DRB Application No.: 11DRB-70252 , Project # 1005354
Project Name: ARBOLEA DE VIDA + SAUNDYLL VILLAGE UNIT 2B
Agent: DEKKER PERICH SABATINI Phone No.:

DRB Application No.: <i>11DRB- 70265</i>	Project # <i>1005354</i>
Project Name: <i>Arbolera De Vida Unit 2B. Sawmill Village</i>	
Agent: <i>Dekker Perich Sabatini</i>	Phone No.:

**Re: Reason for Request
Sawmill Village
Request for Amended Site Development Plan for Subdivision
Tract 2-D of the Arbolera de Vida Subdivision, Albuquerque, NM (Phase 2)
Project # 1005354; 07EPC-00109**

11DRB-70265 MAJOR – SITE DEVELOPMENT PLAN FOR BUILDING PERMIT

2 WEST ELEVATION

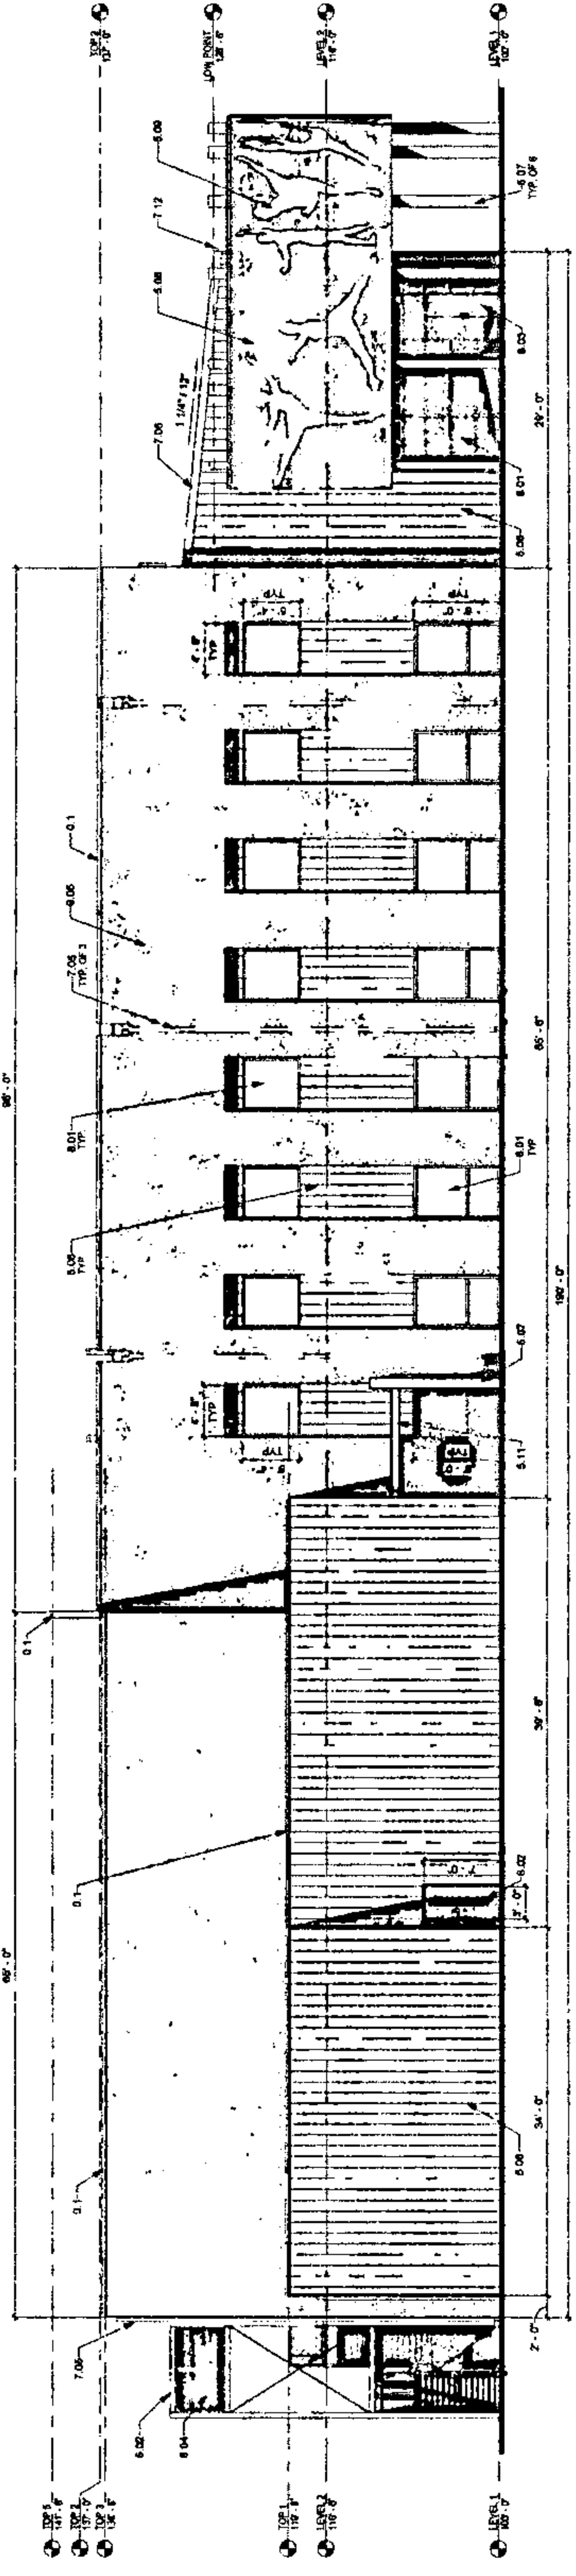
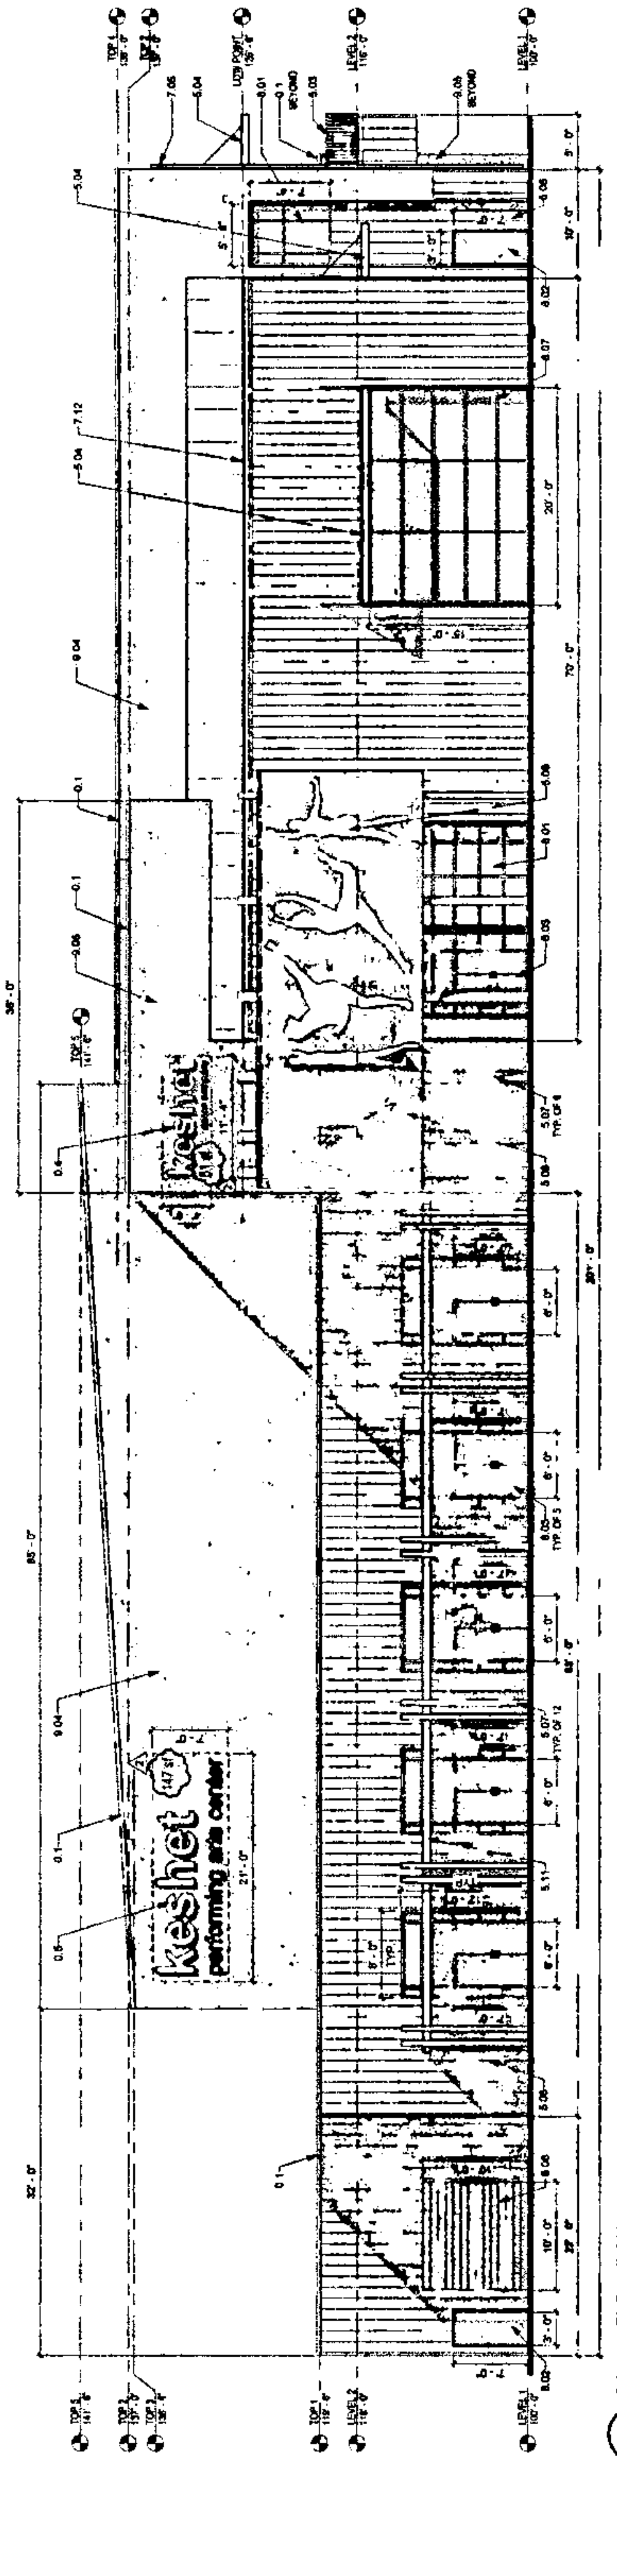
- b. The letter color and square footage of the building mounted signs shall be specified.

- c. Signs shall not be illuminated plastic panel signs (design standard).

RESPONSE: All has been indicated on the building elevations, sheets SDP7 and SDP7A.

RESPONSE: The note internally illuminated signs has been striked from sheets SDP7 and SDP7A.

DRAWING TITLE: **GRADING PLAN**

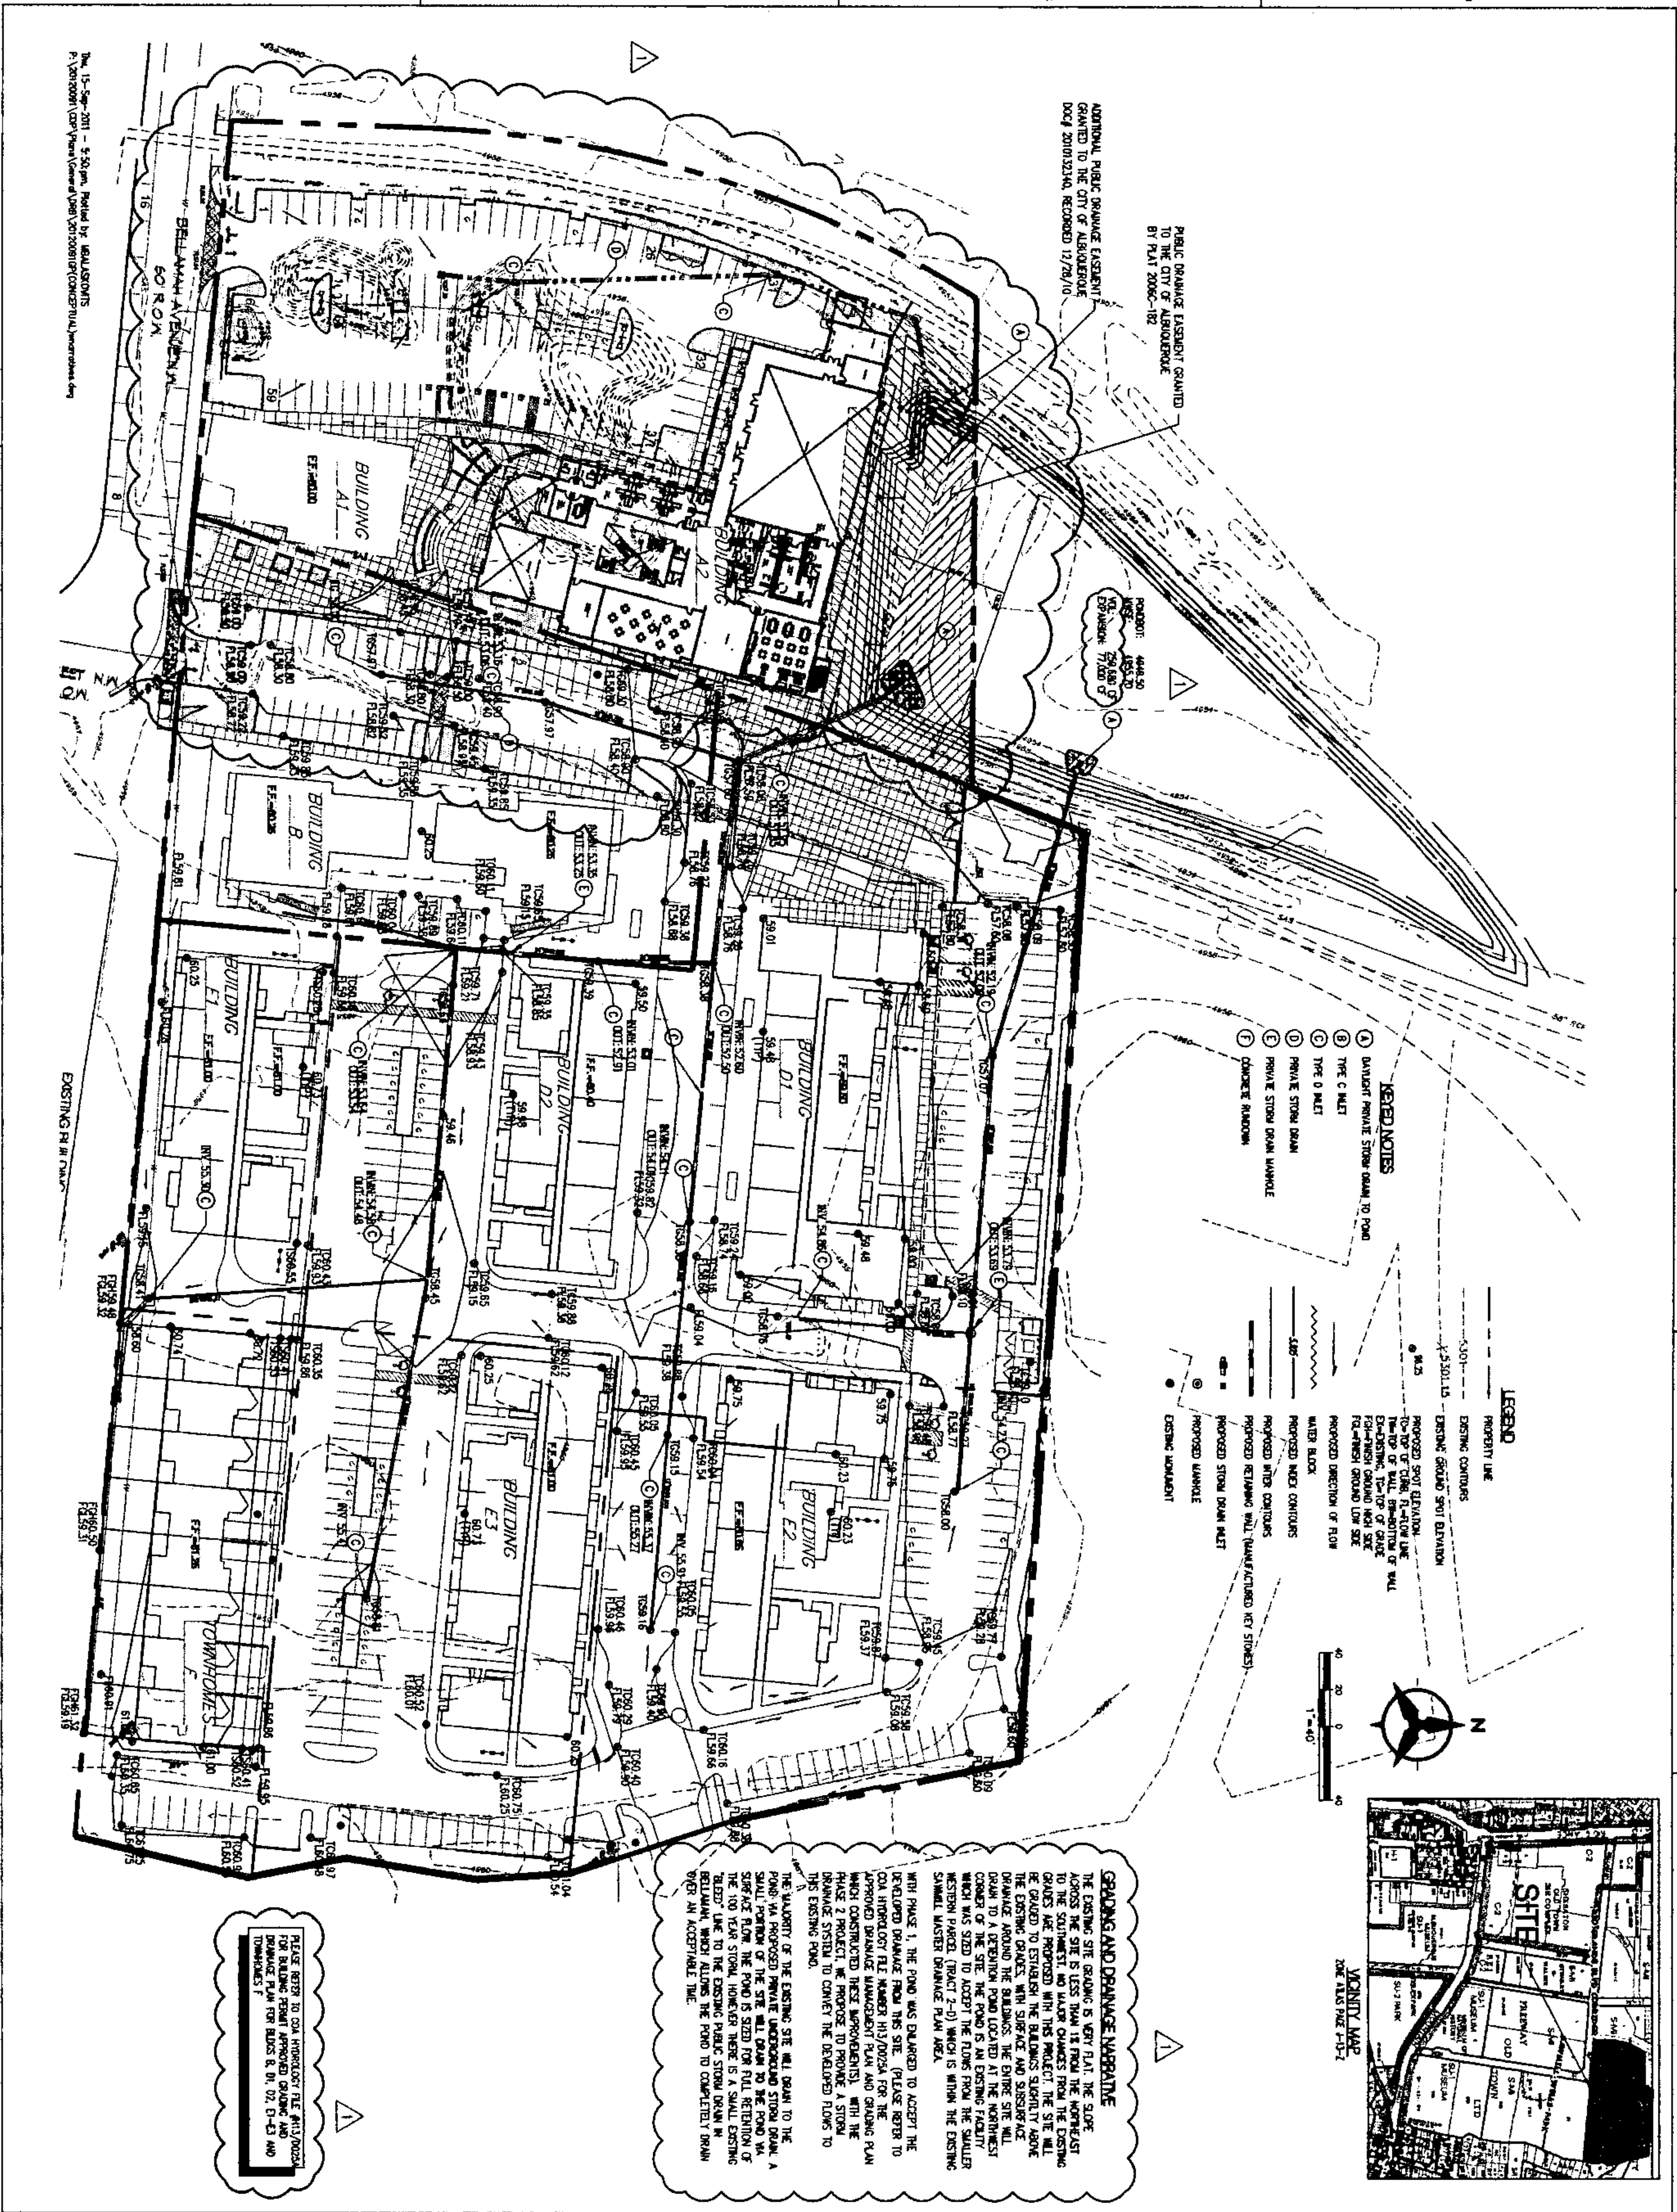
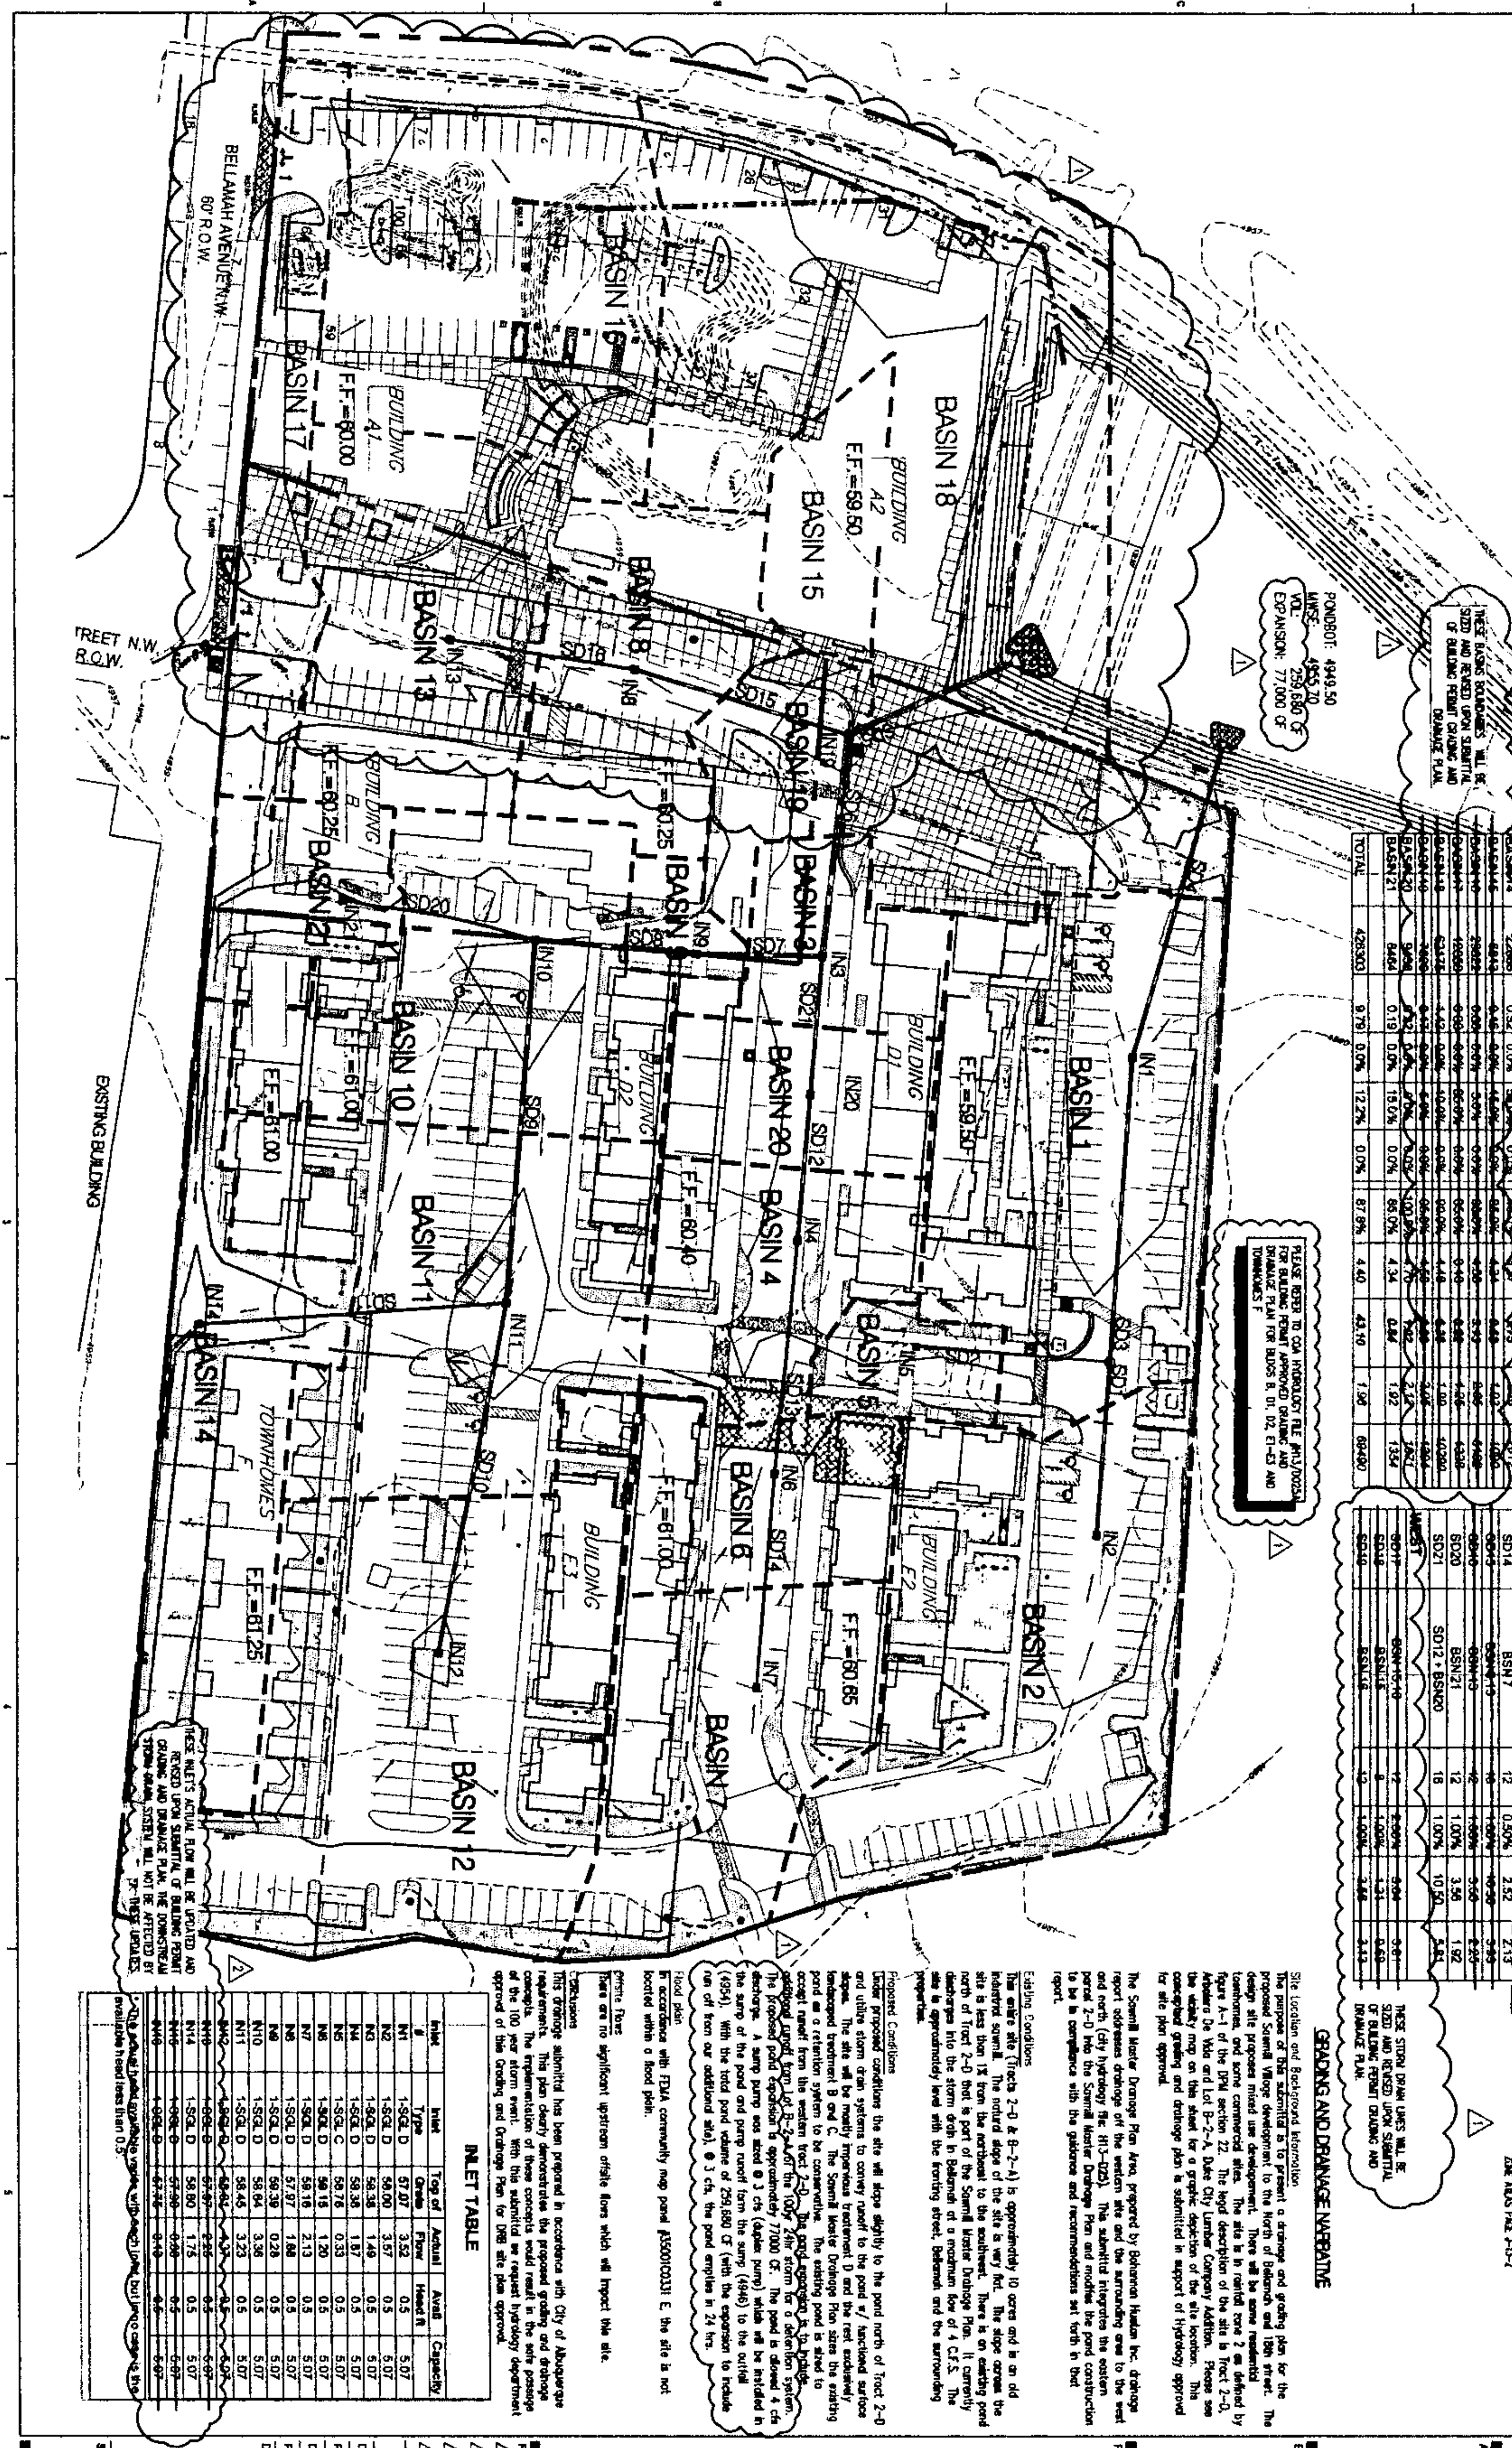
- e. Use bubbling to indicate changes to the tables on the Grading & Drainage plan.

The proposed Building A2 is shown in the drainage easement. The engineer is expected to submit an exhibit that shows the existing pond volume with extents. This will then be used to adjust the drainage easement. The Grading Plan and Conceptual DMP in this packet should be updated to reflect this.

RESPONSE: Bubbling has been indicated.
